Change of Condition Decision

RC235378

APPLICANT:	Hill Street Limited
PROPOSAL:	RC235378 – To change conditions 1 & 2 of resource consent RC225470 (as varied by RC235308)
LOCATION:	545 East Maddisons Road, Rolleston
LEGAL DESCRIPTION:	Lot 1 DP 326339 being 4.0012ha in area more or less, as contained in Record of Title 107005. Lot 56 DP 573266 being 586m ² in area more or less, as contained in Record of Title 1046021.
ZONING:	Operative Selwyn District Plan (2016) The property is zoned Inner Plains under the provisions of the Operative District Plan (Rural) Volume.
STATUS:	RC235378 has been assessed as a change of conditions pursuant to section 127 of the Resource Management Act 1991 in respect of subdivision resource consent RC225470 granted on 24th of January 2023 to undertake a subdivision to create 38 residential allotments ('Lot(s)'); 2 development lots for future comprehensive housing; associated roading and infrastructure services on land Zoned Rural (Inner Plains).

RC 235378 – Change of conditions

Lots 23 - 61, 100 - 104 being Proposed
Subdivision of Lot 1 DP 326339
& Lot 56 DP 573266, 545 East Maddisons Rd

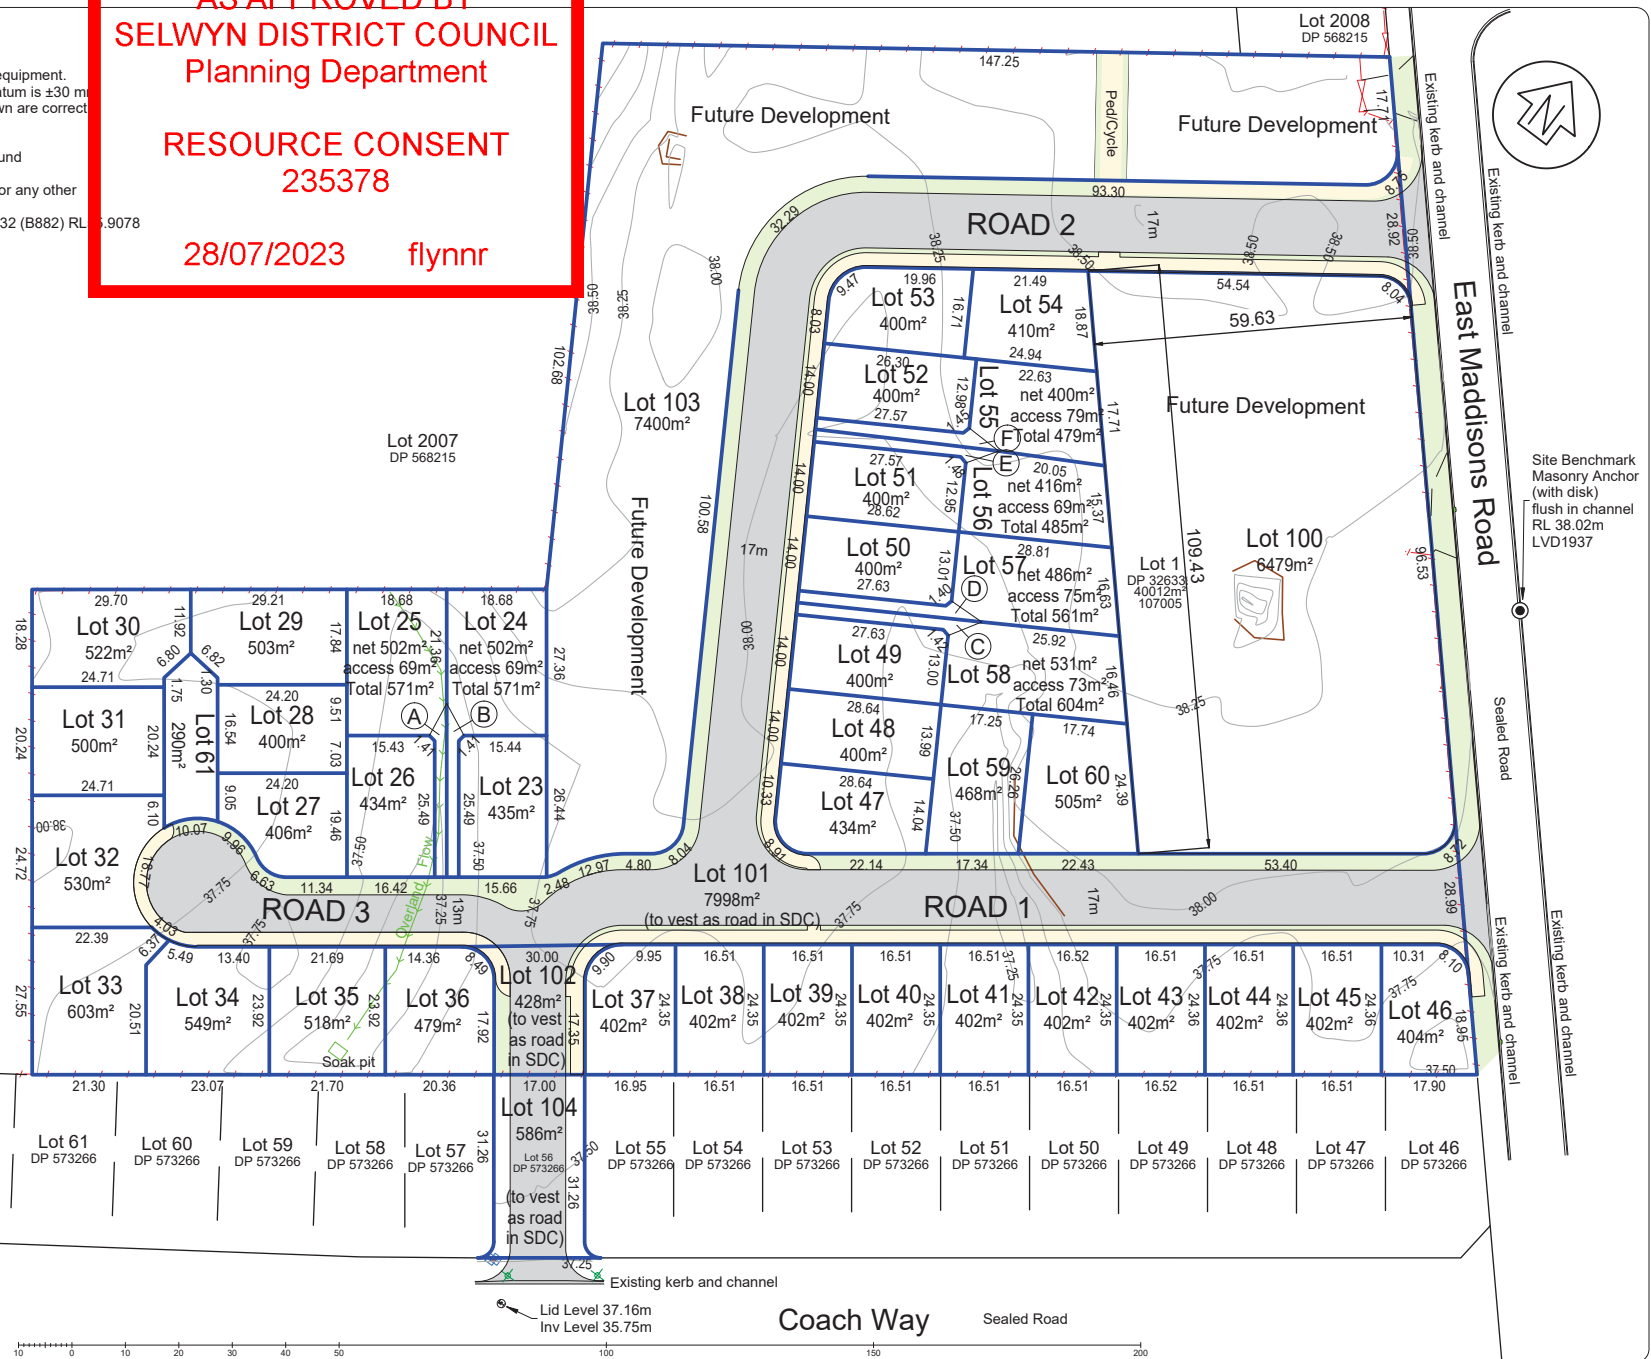
Condition 1 shall now read:

The subdivision shall proceed in general accordance with the information submitted with the application, and the attached approved subdivision plan prepared by Access Land Surveying Ltd., dated 10/07/2023 and entitled "Lots 23 - 61, 100 - 104 being Proposed Subdivision of Lot 1 DP 326339 & Lot 56 DP 573266, 545 East Maddisons Road, Drawing No.: 3572, Sheet 1, Revision B" including any utility lots required.

Condition 2 shall now read:

The consent holder must submit a survey plan in accordance with the approved resource consent subdivision scheme plan titled 'Lots 23 - 61, 100 - 104 being Proposed Subdivision of Lot 1 DP 326339 & Lot 56 DP 573266, 545 East Maddisons Road, Drawing No.: 3572, Sheet 1, Revision B', prepared by Access Land Surveying Ltd, dated 10/07/2023. The survey plan must show all easements, any amalgamation conditions, and any areas subject to covenant required by this subdivision consent.

Issue Details		
Rev.	Description	Date
A	For information	14/11/2022
B	add Lot 104	10/07/2023
